Consolidated Edison Company of New York, Inc.  
4 Irving Place, New York, N Y 10003  
Telephone (212) 460-3819

Re: Indian Point Unit No. 2  
Docket No. 50-247

Responses to Questions for Additional  
Information

Responses to Staff Positions

**FIGURE Q12-1**  
**INDIAN POINT STATION**  
**FIRE PROTECTION SYSTEM**

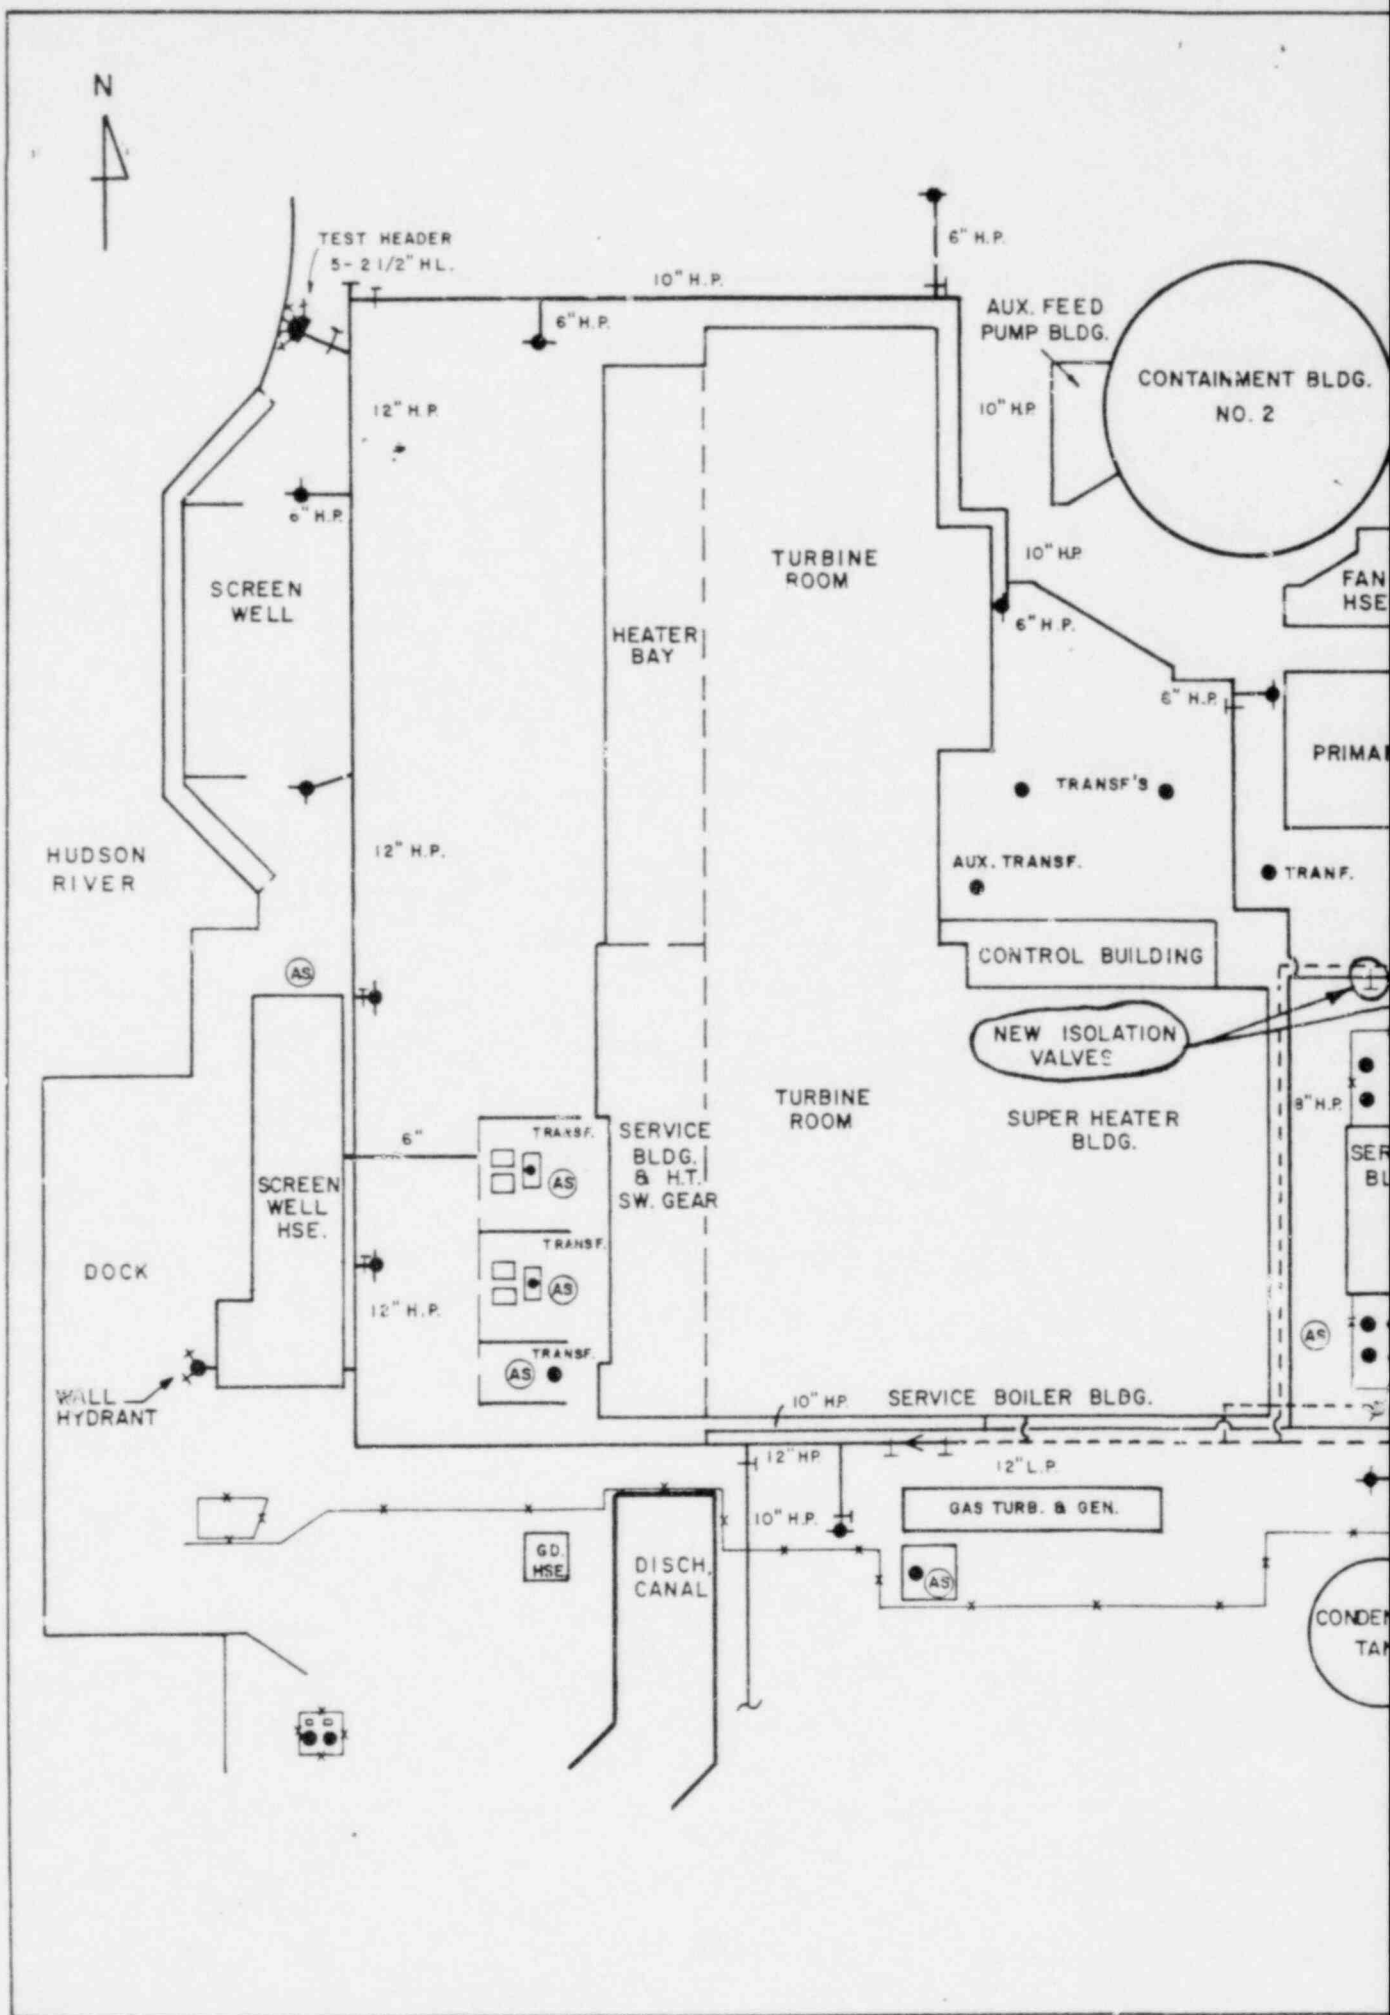
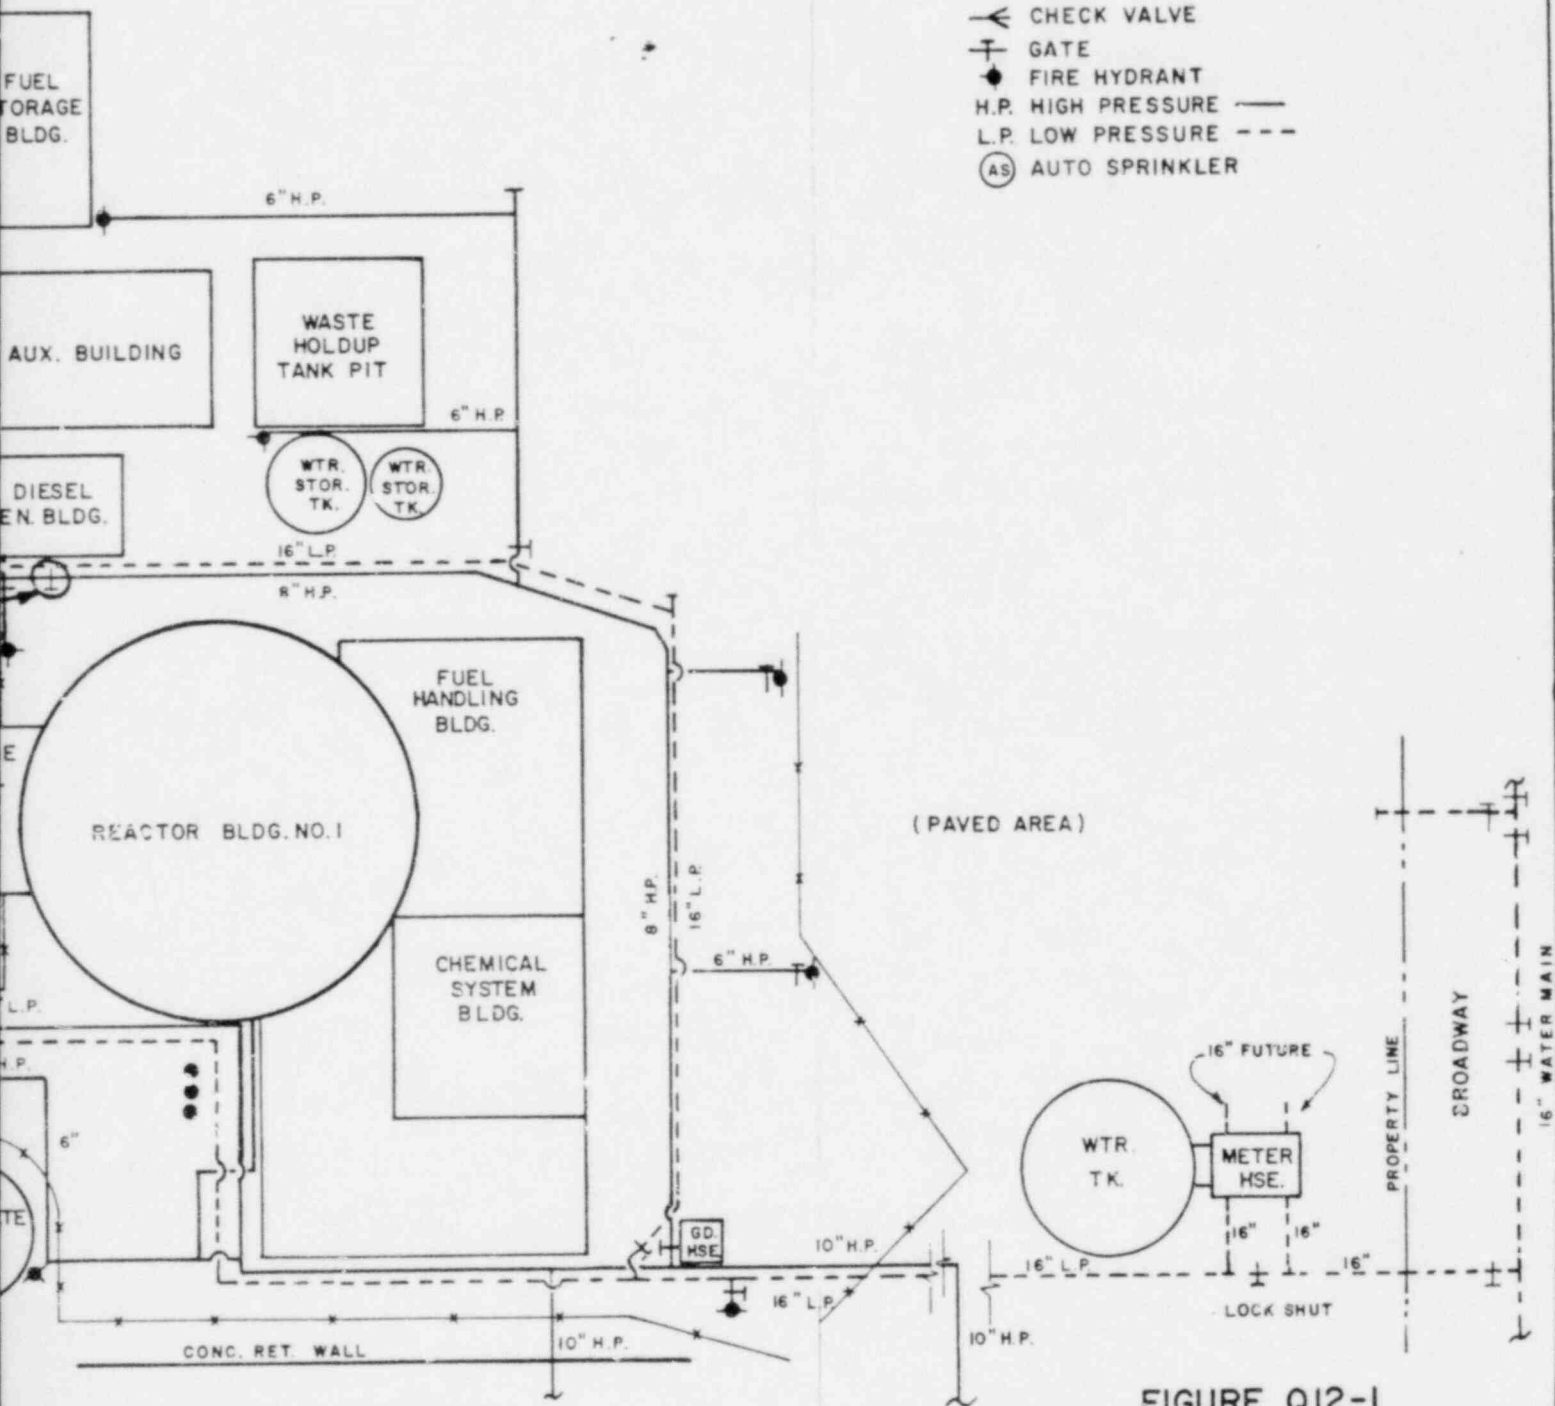
Provide a P&ID of the fire water system overlaid on the plant layout, including the yard loop and showing where the new isolation valve is to be located.

Presently, a break in the high pressure fire loop may result in loss of both sprinklers and hose hydrants for the diesel generator building. To preclude loss of primary and backup suppression capability to this building, an additional sectionalizing valve should be installed in the high pressure fire loop between the hydrant serving the diesel generator building and the takeoff for the header supplying diesel generator building sprinkler systems.

A physical layout of the fire water system is shown in Figure Q12-1.

A sectionalizing valve will be added to the yard main loop on each side of the take-off for the Diesel Generator Building. The use of two (2) valves will ensure that a break in any portion of the loop (except for the short distance between the two valves) will not incapacitate the sprinkler system. The location of valves is shown on Figure Q12-1 provided in response to Question No. 12 (Enclosure 1).

Figure P29-1

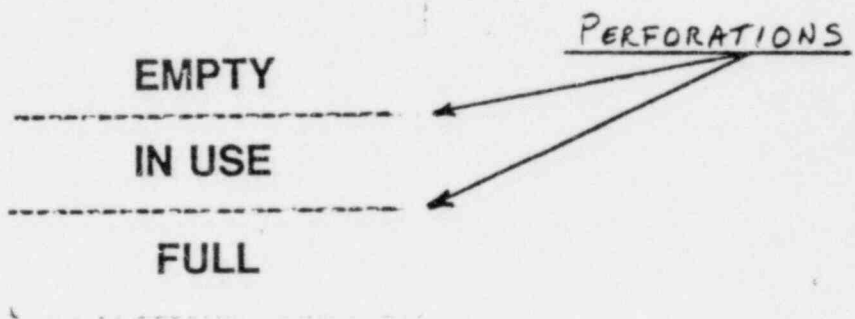
The system should be improved to readily distinguish between the full and expended air storage bottles for use in the air mask bottle cascade refilling assembly.

All high pressure air storage cylinders, which are part of the cascade refilling assembly, will be equipped with the three part tag illustrated on Figure P29-1 or an equivalent tag which will provide a method of distinguishing between full and empty cylinders.
